Access Compliance Report

Public Rights-of-Way

Intersection ID: 14201	Main Street: RANLO_AV	Cross Street: BALDWIN_AV	Location: NW
ADA ID: F29FE169259C	Ramp Type: Perp	Initial Pass/Fail: Fail	Overall Compliance: No
		Severity Score: 25

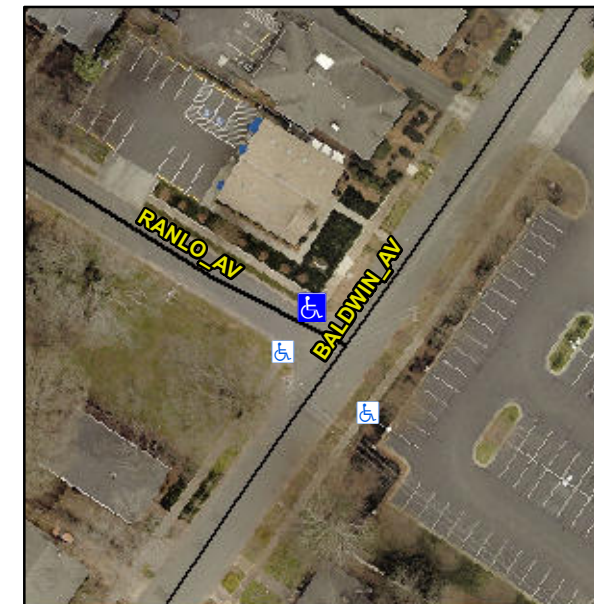
R304.2.2

Compliance	Description	Data	Compliance	Description	Data
N/A	Ramp Length (in)	48.0	No	Ramp Slope (%)	12.1
Yes	Ramp Width (in)	48.0	Yes	Ramp XSlope (%)	1.9
N/A	Flare Type LT	N/A	N/A	Flare Type RT	N/A
N/A	Flare Slope LT (%)	N/A	N/A	Flare Slope RT (%)	N/A
N/A	Flare Traversable LT?	N/A	N/A	Flare Traversable RT?	N/A
N/A	Landing Length (in)	N/A	N/A	DWS Provided?	N/A
N/A	Landing Width (in)	N/A	N/A	DWS Contrast?	N/A
N/A	Landing Slope (%)	N/A	N/A	DWS Length (in)	N/A
N/A	Landing X Slope (%)	N/A	N/A	DWS Full Width?	N/A
N/A	Landing Curb? (Y/N)	N/A	N/A	DWS Offset (in)	N/A
N/A	Shared Landing?	N/A			
N/A	Gutter Ponding?	N/A	N/A	Gutter Slope (%)	N/A
N/A	Gutter Lip Ht (in)	N/A	N/A	Gutter X Slope (%)	N/A
N/A	Painted X Walk1?	No	N/A	Painted X Walk2?	N/A
	X Walk 1 Direction	To SW		X Walk 2 Direction	N/A
N/A	X Walk 1 Width (in)	N/A	N/A	X Walk 2 Width (in)	N/A
	X Walk 1 Slope (%)	1.6		X Walk 2 Slope (%)	N/A
	X Walk 1 X Slope (%)	1.0		X Walk 2 X Slope (%)	N/A

Remove & Replace Entire Ramp.
